Hydrogeological Assessment of impact of the
proposed Wasperton sand & gravel quarry

For The Barford Residents Association

July 2023

Figure 2.5 Cross section

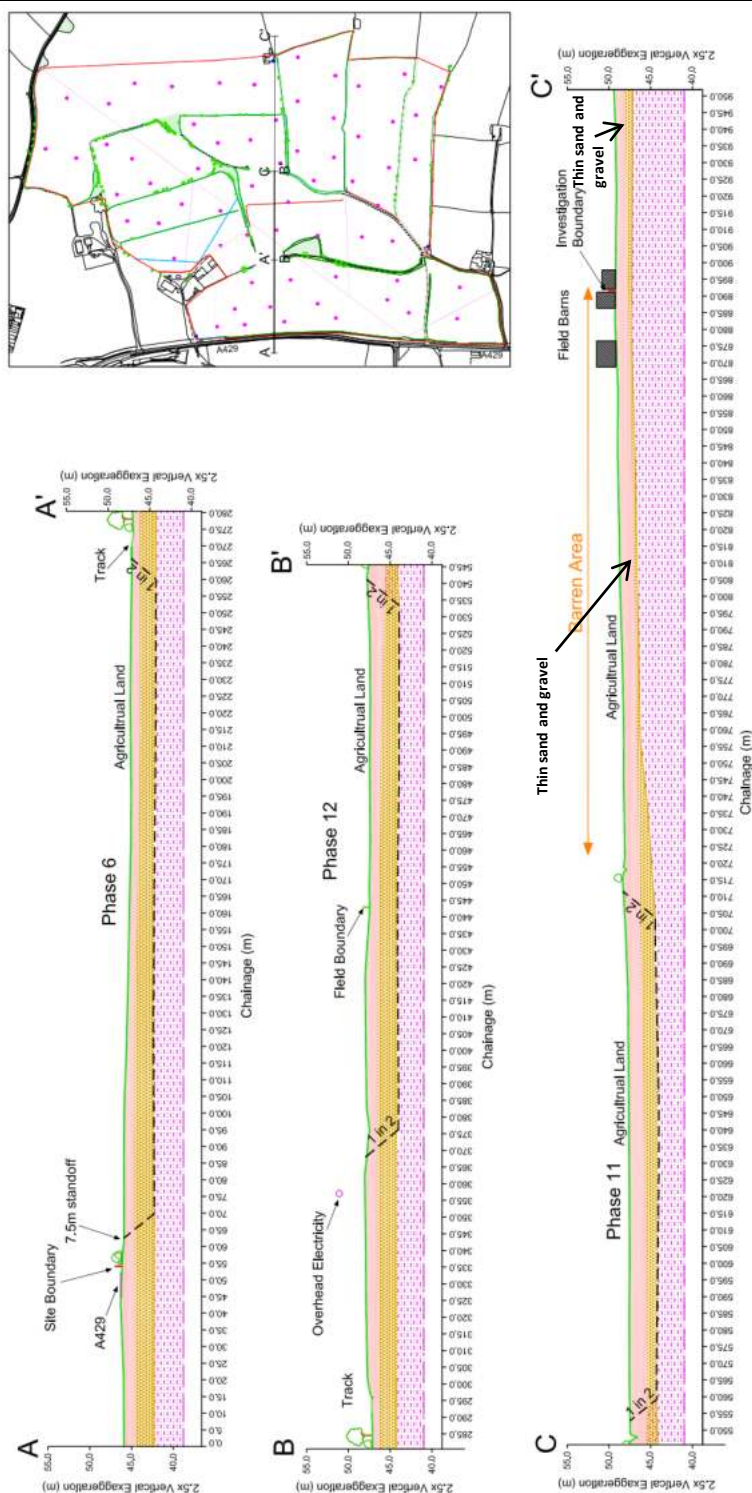
- 2.7 A cross section provided by the applicant and shown in the application documents as Plan WSP 22-6 Cross Section is shown below as Figure 2.5. The three elements are to be put together and show the gentle slope of the ground surface (green), the rockhead (as a pink hatched block), then sand and gravel (as a gold coloured block), and the thickness of the overburden (as a salmon pink block).

- 2.8 The section shows a thin layer of sand and gravel in the area marked on other maps provided as “barren”, a term that may suggest that there is no sand and gravel. This thin layer provides an important role in allowing surface runoff from the hillside to the east to enter the sand and gravel as recharge,

- 2.9 The land surface to the east of the site quickly rises to 70 mOD within 650 m from the end of the section. This slope has an average gradient of 1 in 9.3 which may also be stated as 0.31 or 31%. This is sufficiently steep to encourage heavy rain to runoff down the slope being concentrated in the valleys shown by the ground contour shapes, from where it will recharge the river terrace gravels. This is in contrast with the proposed restoration where the material that it is proposed to replace the sand and gravel will be material with a low effective porosity and will not be able to absorb the water in the same way therefore causing the groundwater levels to rise and the prospect of flooding increased.

Figure 4.6 Rockhead elevations

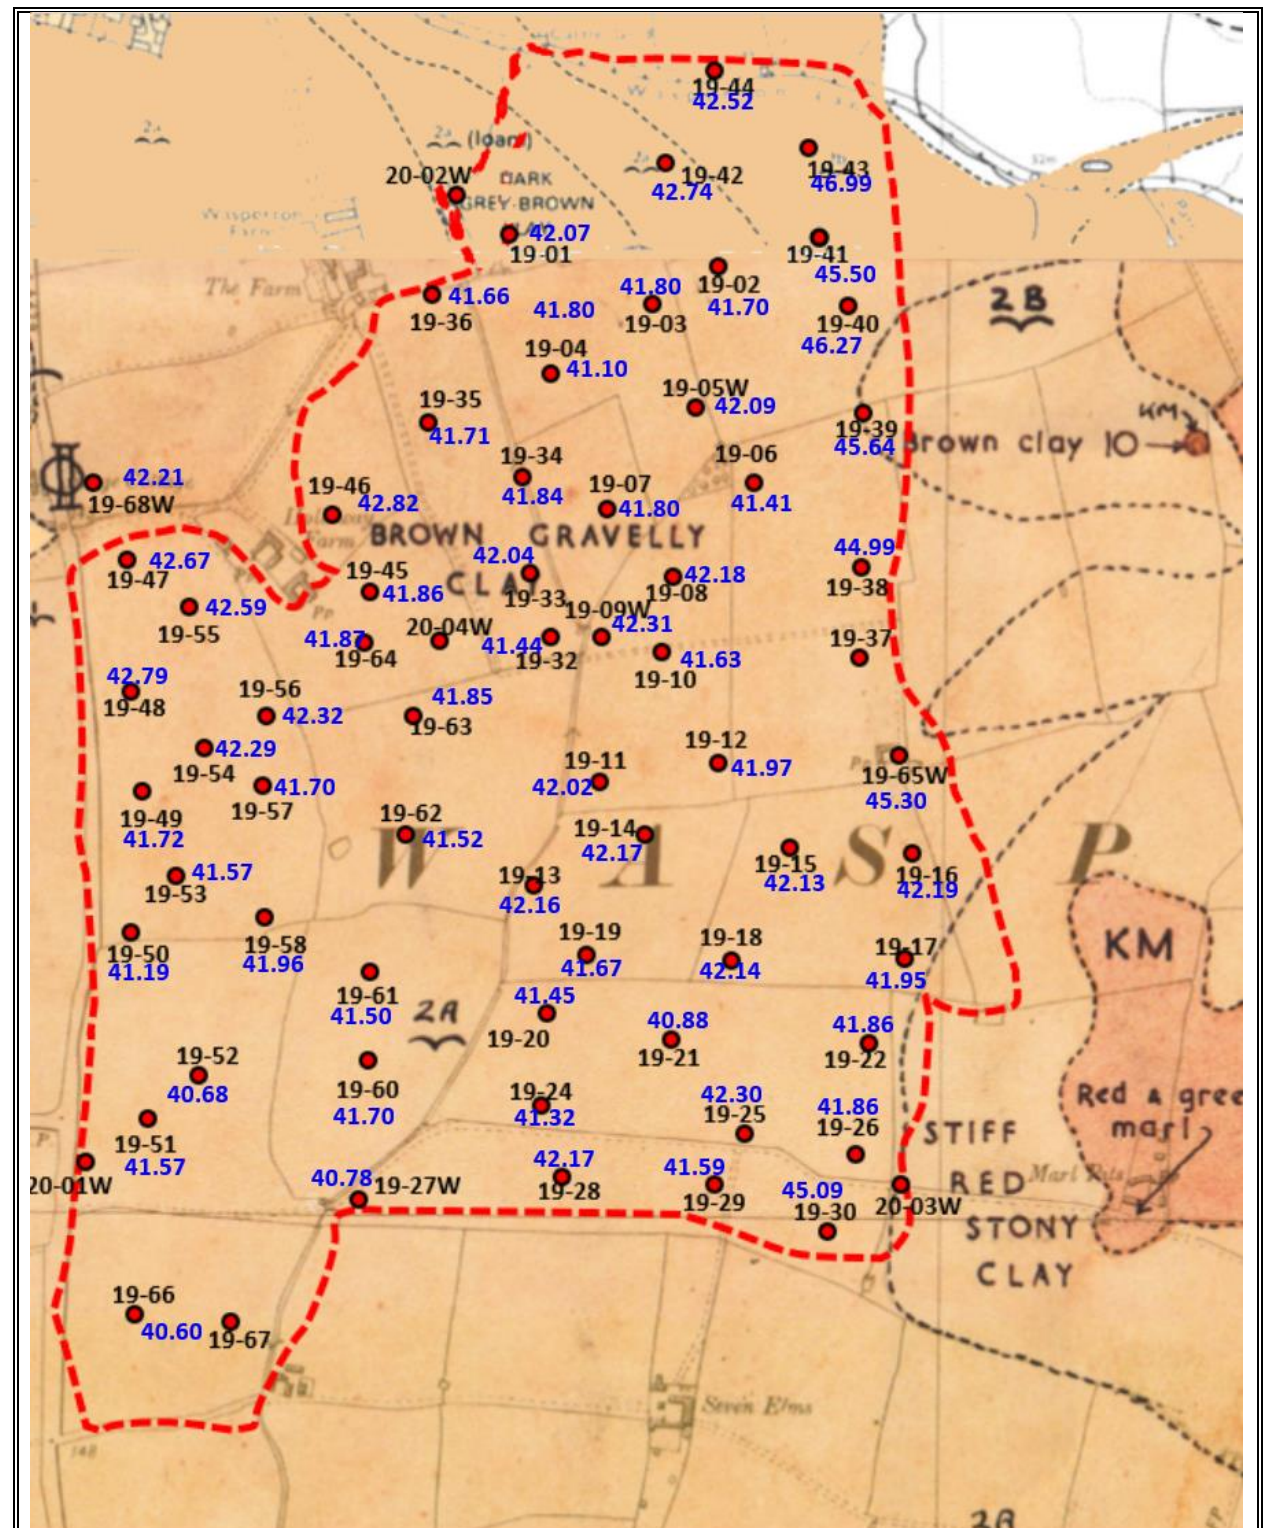
- 4.52 The data from the boreholes has been used to construct a rockhead map in this evaluation of the application. This is shown on a map in Figure 4.6 with elevations shown in metres above Ordnance Datum. This information shows that the elevation of the rockhead falls in a southwestwardly direction although it is a slightly more complex with small upstanding areas across the site.

- 4.53 The rockhead elevations shown in Figure 4.6 indicate that the lowest values are at 40.21 mOD. The River Avon is at elevations along its length from a point opposite the entrance to Wasperton Farm to near Wasperton village lies at values just below 40 mOD which indicates that flow from the River Avon through the sand and gravel deposits into open quarried cells may not be possible except during a time of flood. Again the applicant does not provide any information on this aspect.

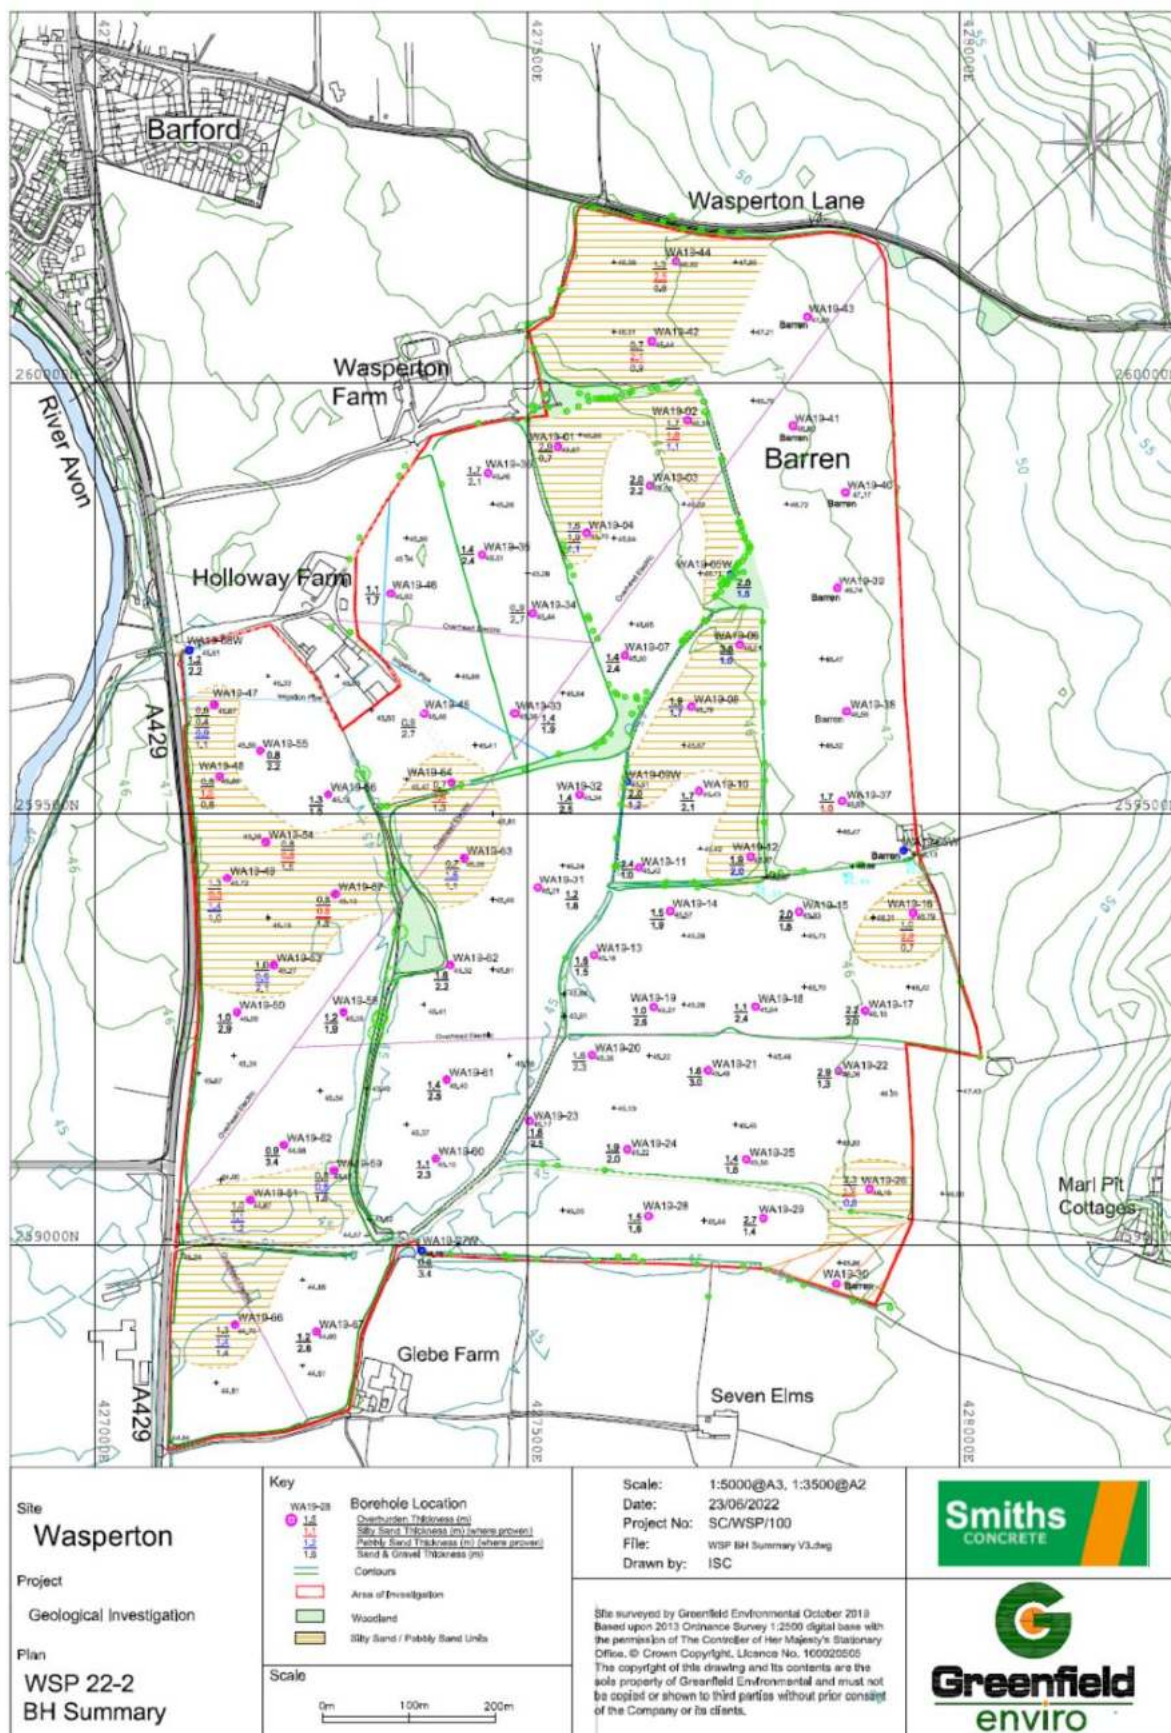
Map WSP 22-2 BH Summary shows more information on the distribution of the geological information. Unfortunately the yellow horizontal striped areas show silt and pebbles in the sand and gravel material which is not helpful as these properties provide different effects on the hydraulic conductivity and storativity of the aquifer materials and this devalues the map.

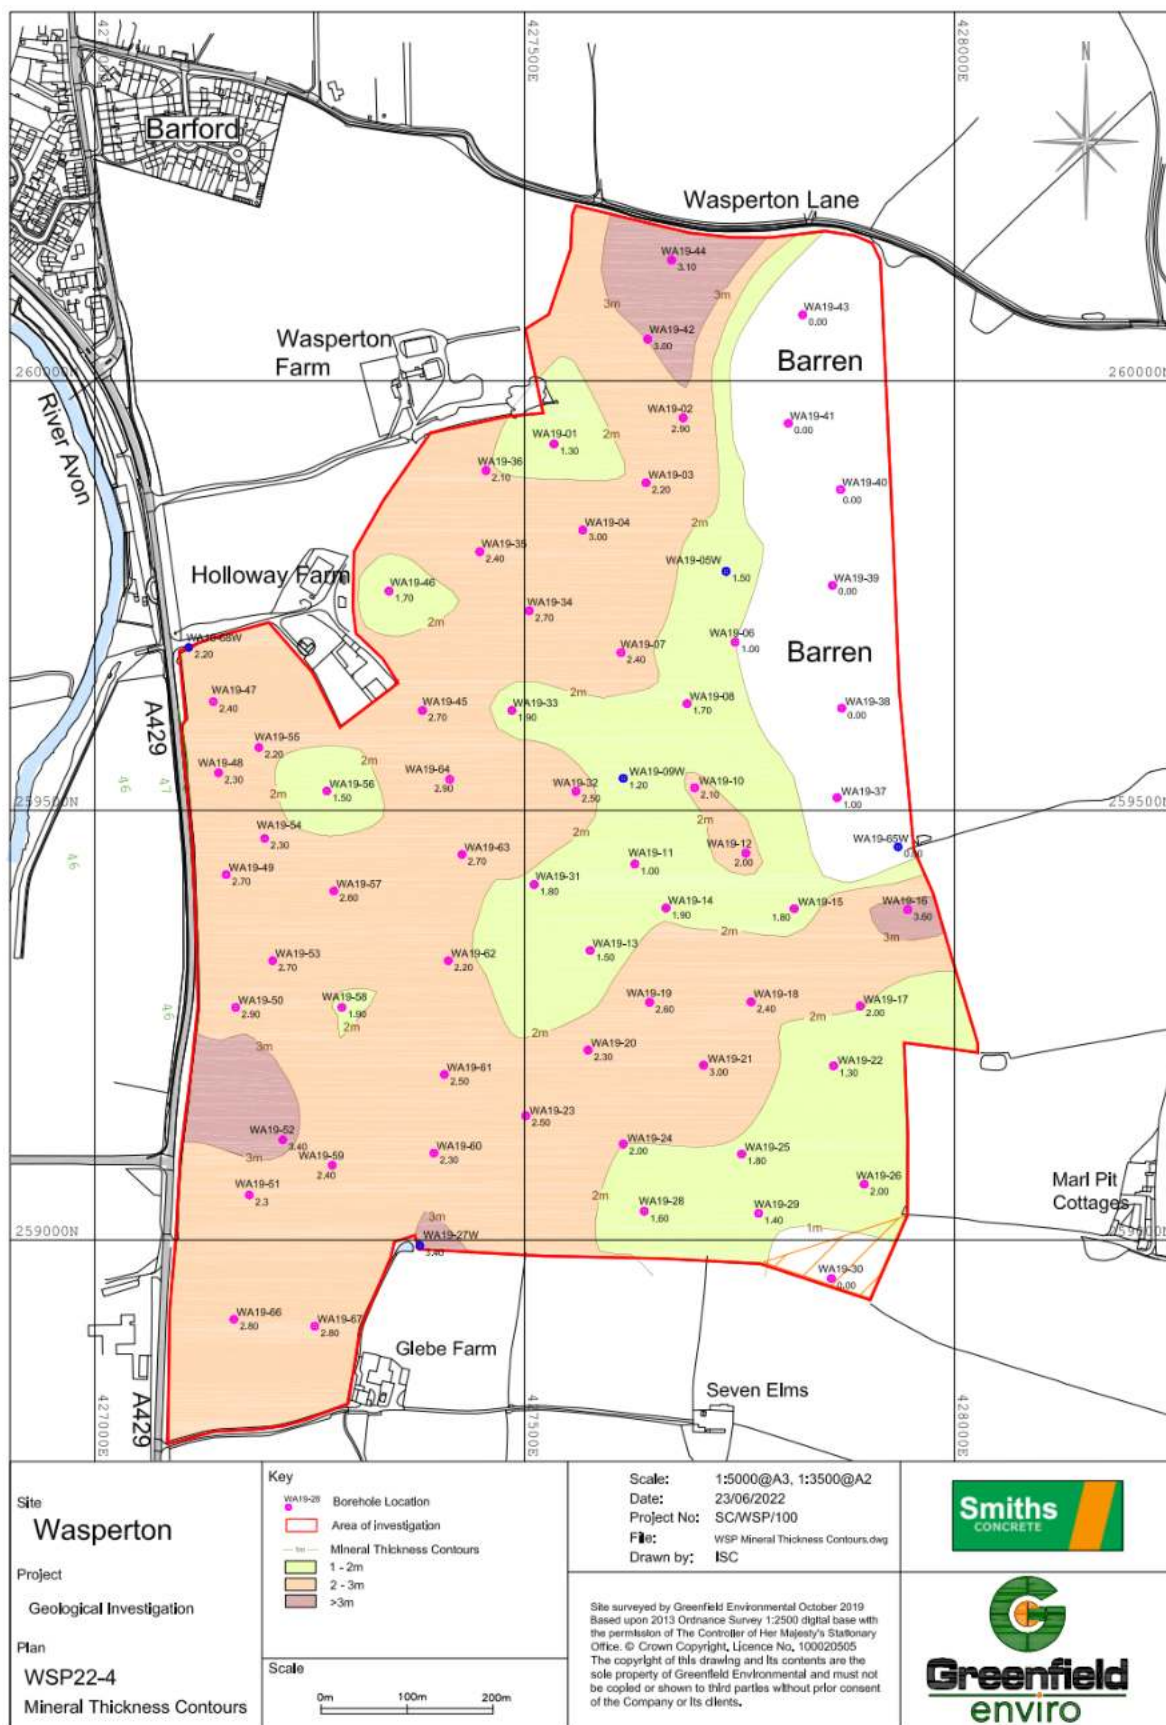
Map WSP 22-4 Mineral Thickness Contours shows the thicknesses in units of 1-2 m, 2-3 m and < 3 m. There is no information on the less than 1 m thickness for the sand and gravel.

These maps provide some information from the boreholes logs although copies of the actual logs that were provided to the applicant by the driller would have been very much more helpful.
